Concerning Comments On 25GBASE- LR and 25GBASE-ER Interoperation

20170111

Specifications (From P802.3cc D2.0)

25GBASE-LR and 25GBASE-ER Interconnected With 4dB Attenuator – OMA

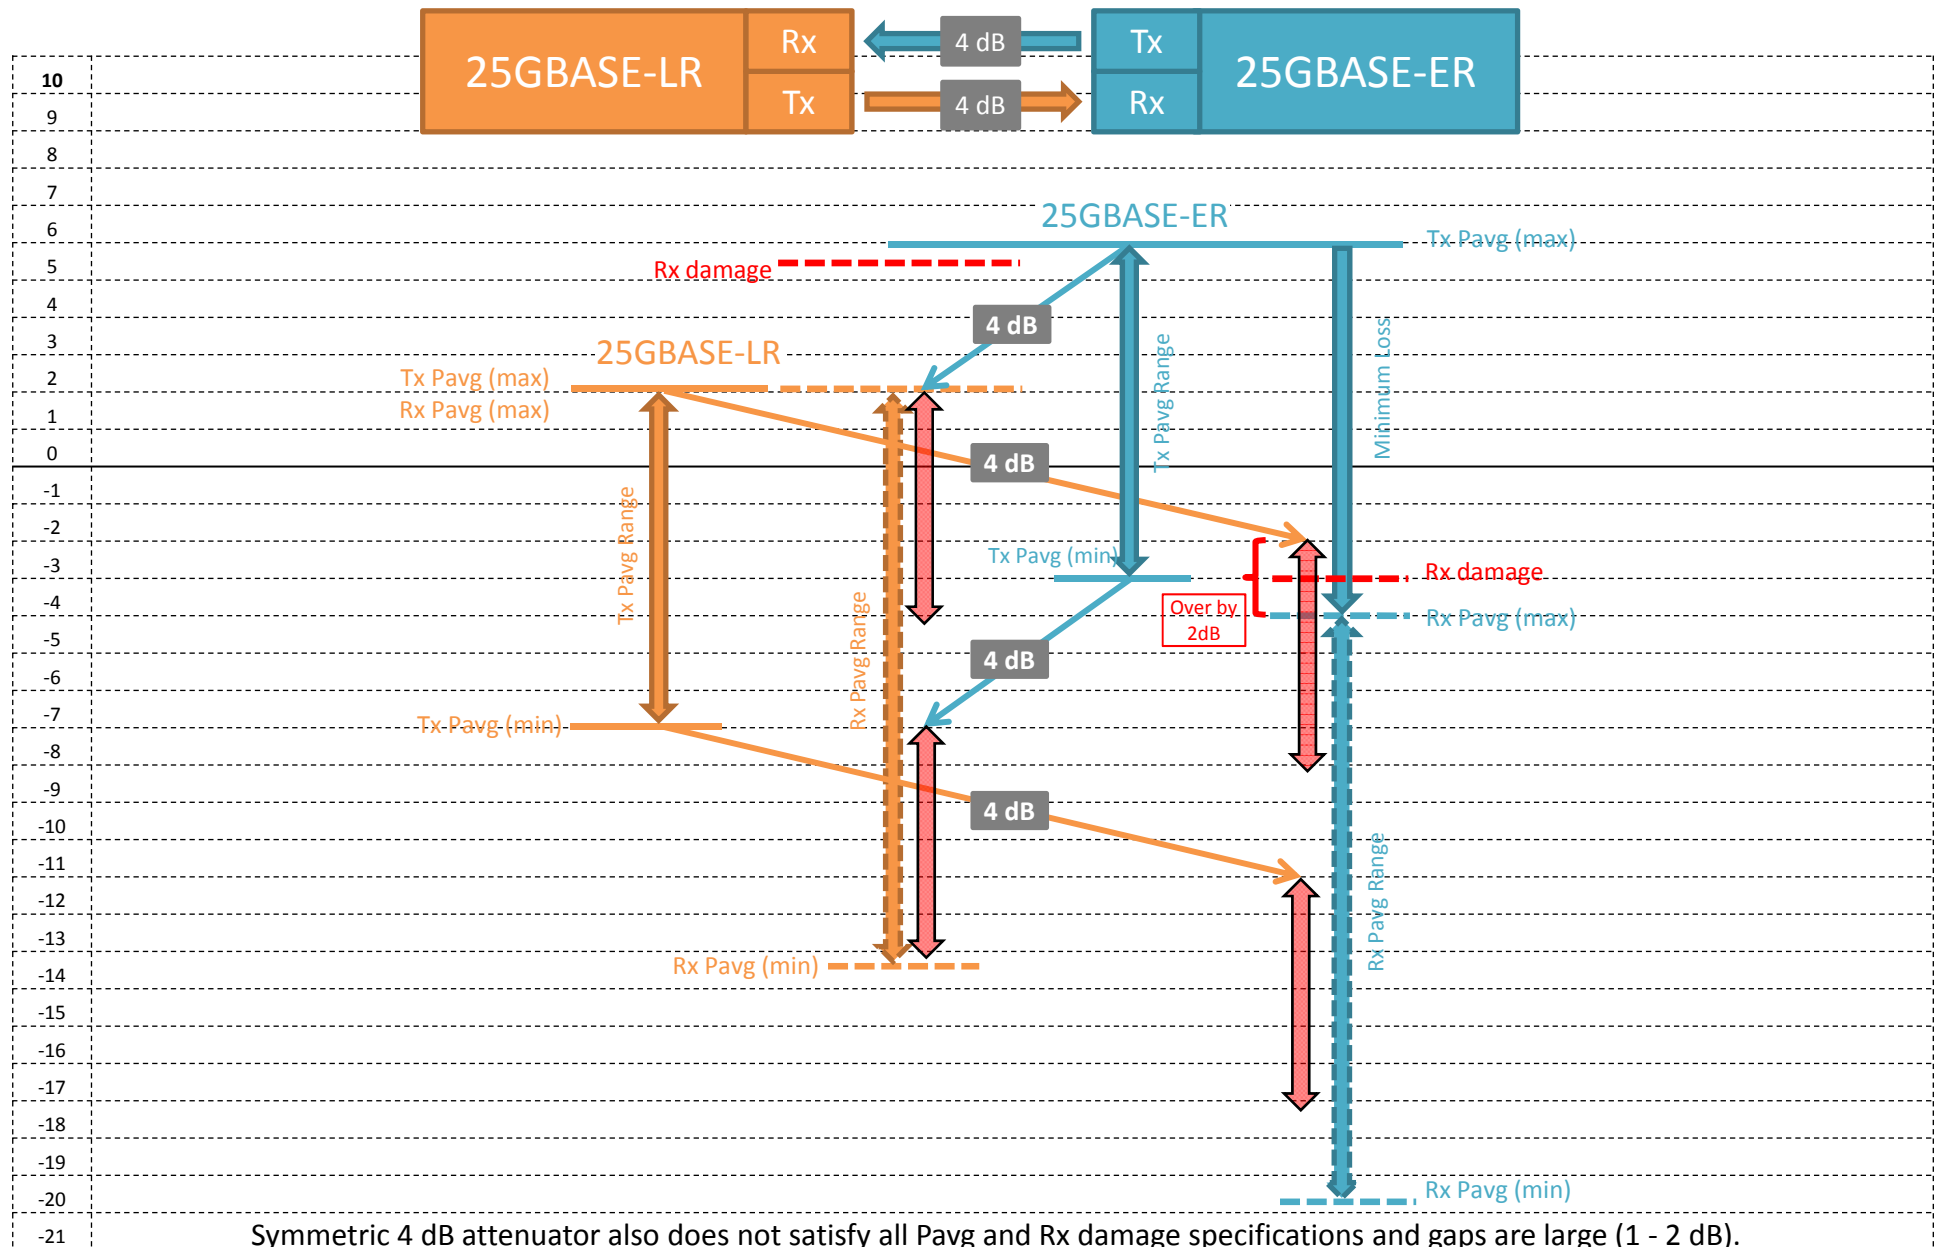
1. Several comments indicated that the conditions for interoperability of 25GBASE-LR and 25GBASE-ER needed clarification to ensure that the min/max specifications for OMA and average power (P_{avg}) are satisfied.
2. One possible solution is the following:
 1. For channel loss of 0 – 4 dB:
 1. Require 5 ± 1 dB attenuator when connecting 25GBASE-ER transmitter (Tx) to 25GBASE-LR receiver (Rx).
 2. Require 8 ± 1 dB attenuator when connecting 25GBASE-LR Tx to 25GBASE-ER Rx.
 2. For channel loss of 3 – 6.3 dB:
 1. Require 2 ± 1 dB attenuator when connecting 25GBASE-ER Tx to 25GBASE-LR Rx.
 2. Require 5 ± 1 dB attenuator when connecting 25GBASE-LR Tx to 25GBASE-ER Rx.

25GBASE-LR and 25GBASE-ER Interconnection Attenuator Tolerance Considerations – OMA

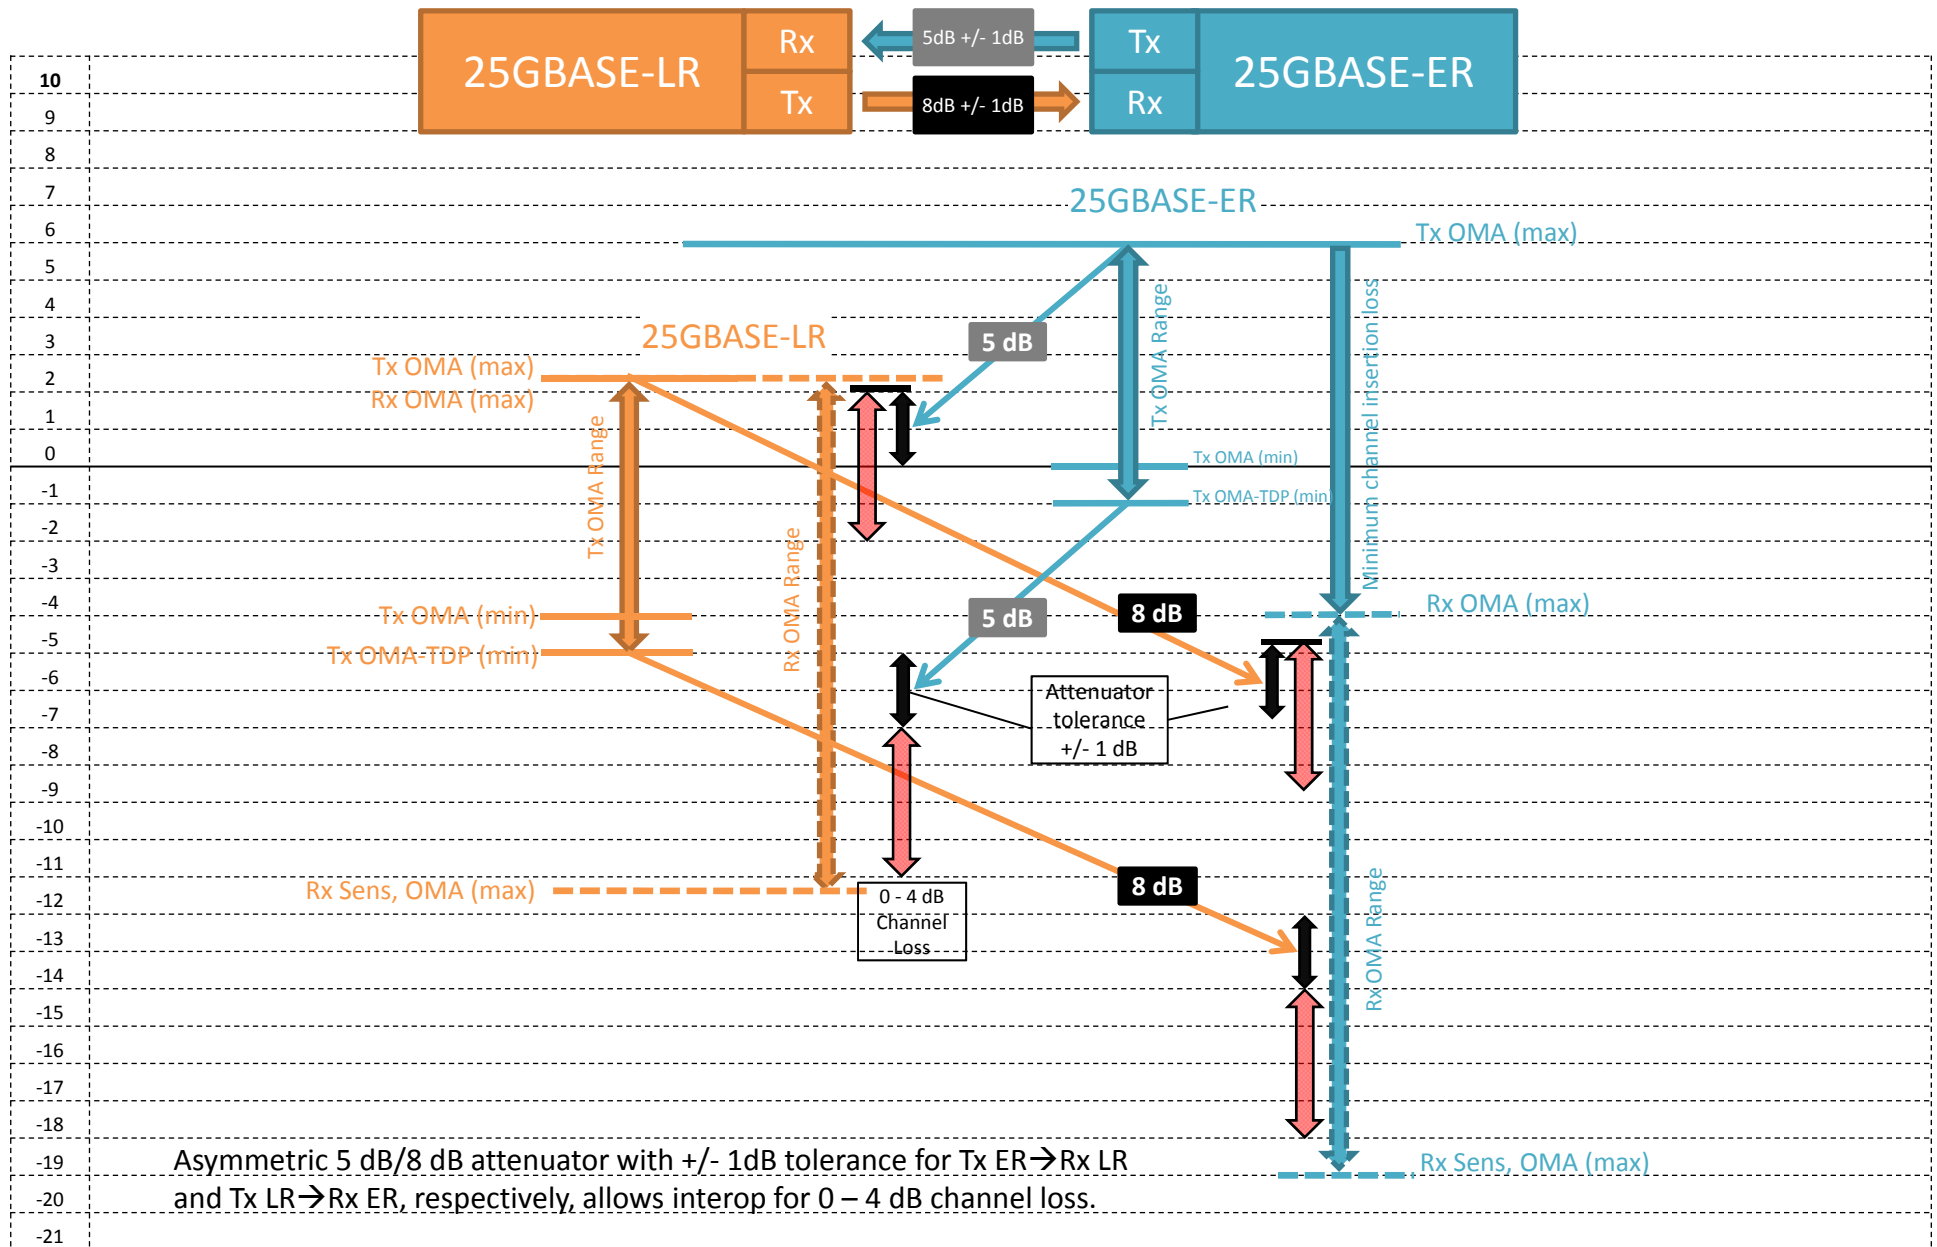
Channel Loss of 0-4 dB

1. For channel loss of 0 – 4 dB:
 1. Require 5 ± 1 dB attenuator when connecting 25GBASE-ER transmitter (Tx) to 25GBASE-LR receiver (Rx).
 2. Require 8 ± 1 dB attenuator when connecting 25GBASE-LR Tx to 25GBASE-ER Rx.

25GBASE-LR and 25GBASE-ER Interconnection Attenuator Tolerance Considerations – OMA

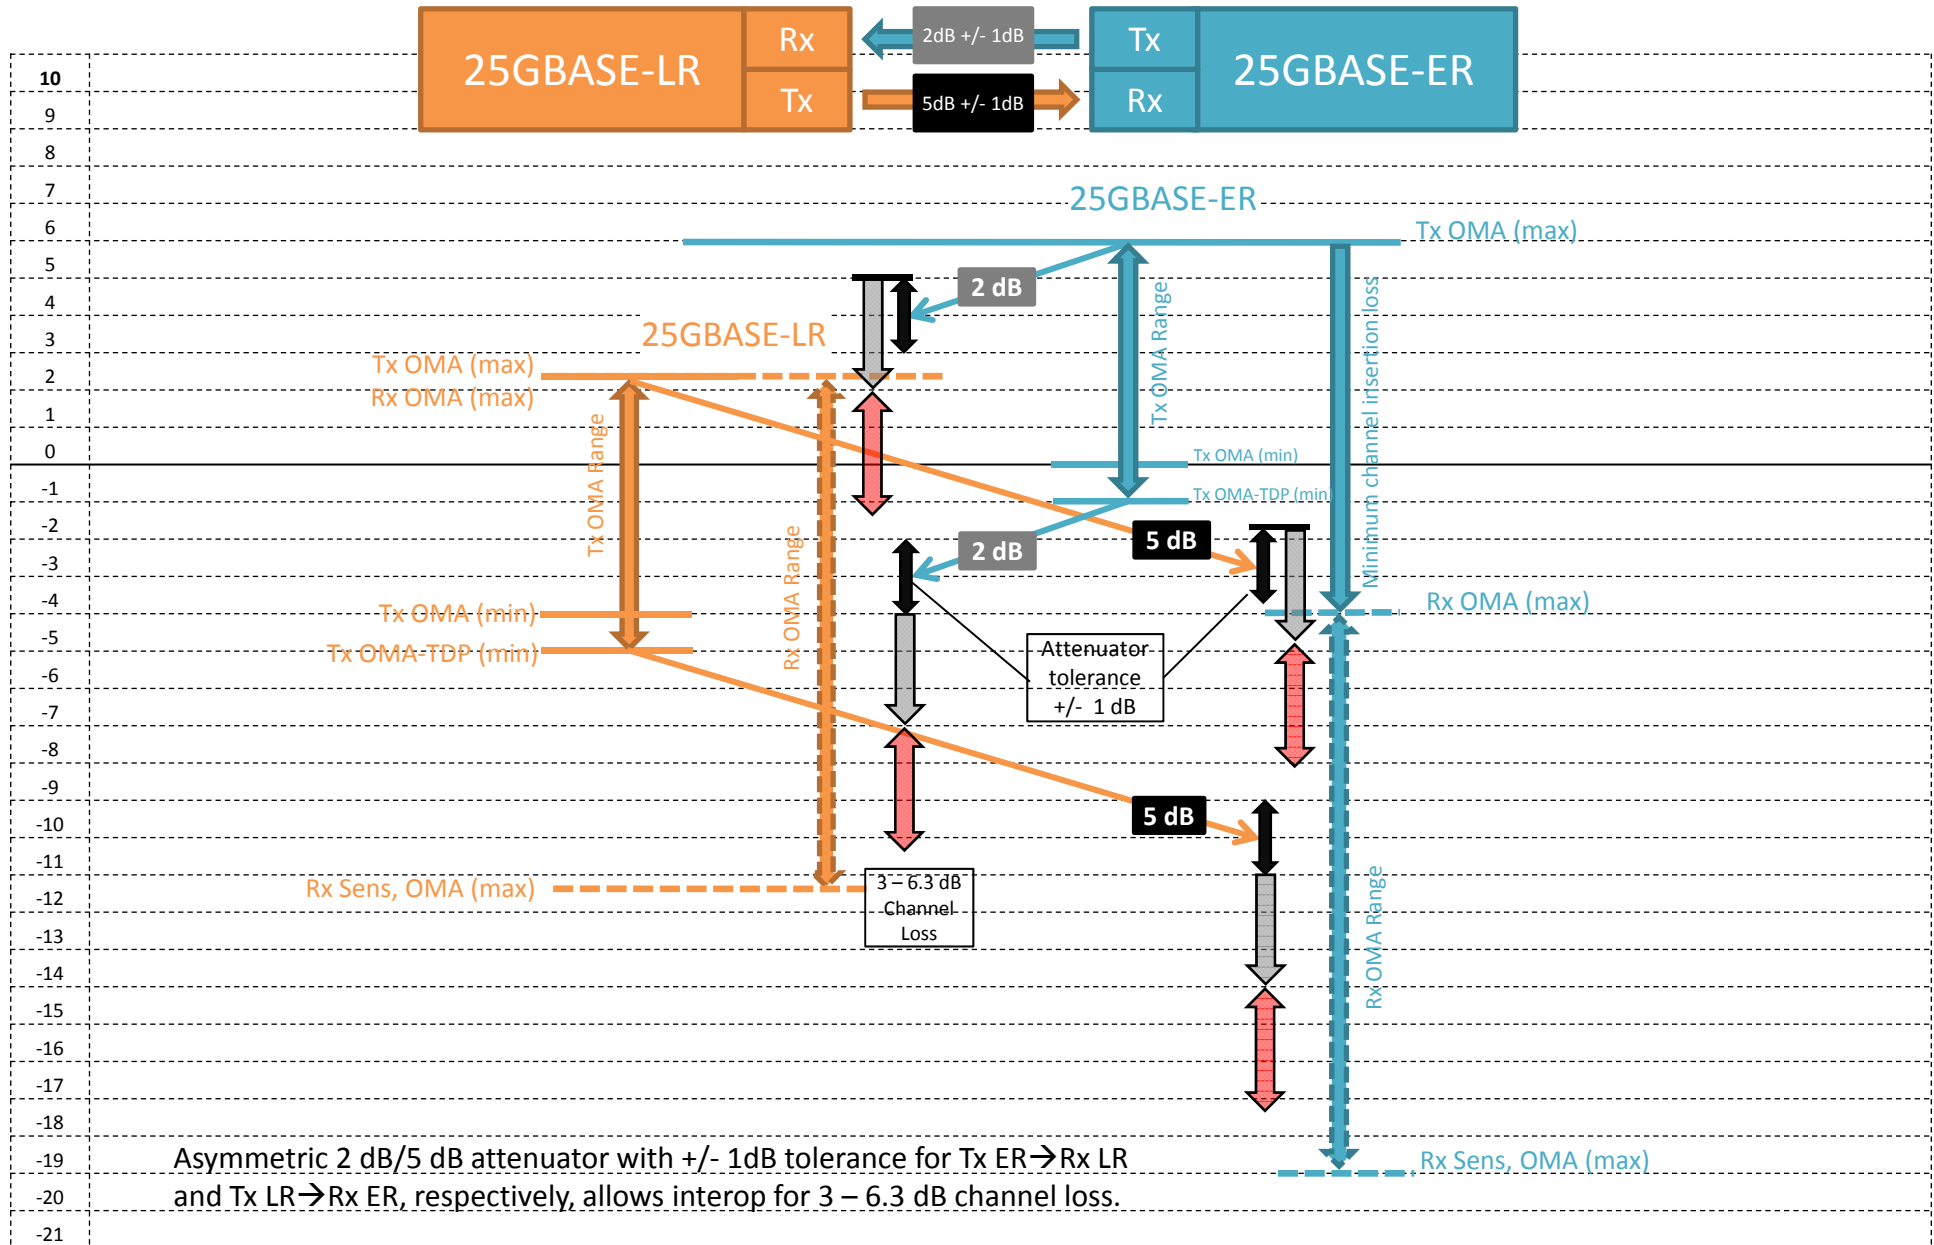
Channel Loss of 3 – 6.3 dB

2. For channel loss of 3 – 6.3 dB:
 1. Require 2 ± 1 dB attenuator when connecting 25GBASE-ER Tx to 25GBASE-LR Rx.
 2. Require 5 ± 1 dB attenuator when connecting 25GBASE-LR Tx to 25GBASE-ER Rx.
